## Christianson Ladder Hinge Repair Kit Installation

It has been decided the vehicles in this recall population may have been manufactured with a Christianson Industries ladder that folds up against the unit. The mounting bracket on the ladder could separate from the hinge due to an incorrect weld. There are six hinges on each ladder; the likelihood of all six hinges failing at the same time is remote.

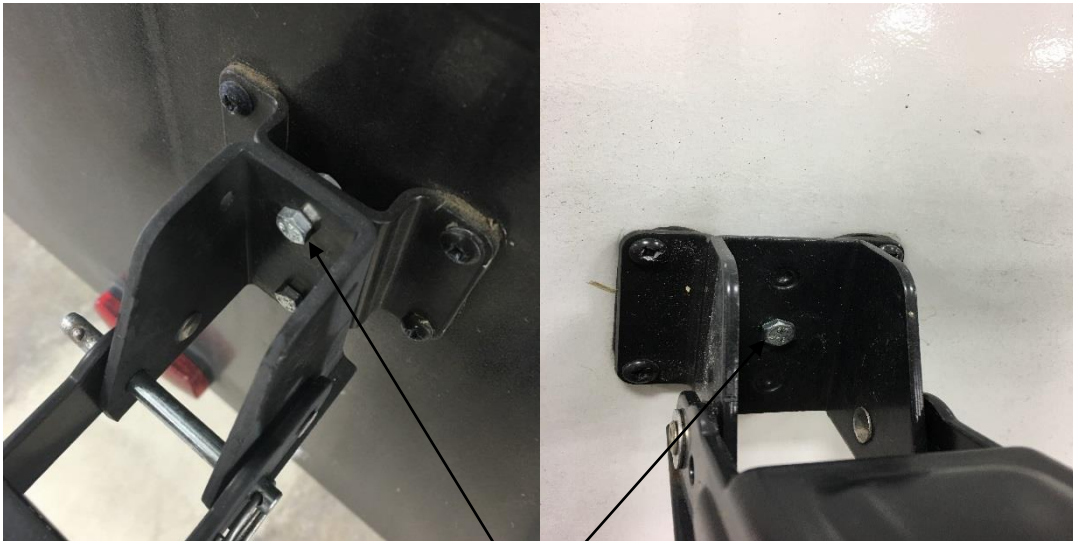
2. Old style bracket, is welded together and requires the addition of the kit.

Bracket is  
welded to  
hinge

3. Follow the Bracket installation instructions provided with the Bracket kit.

Ladder Bracket Kit Part # 0263469
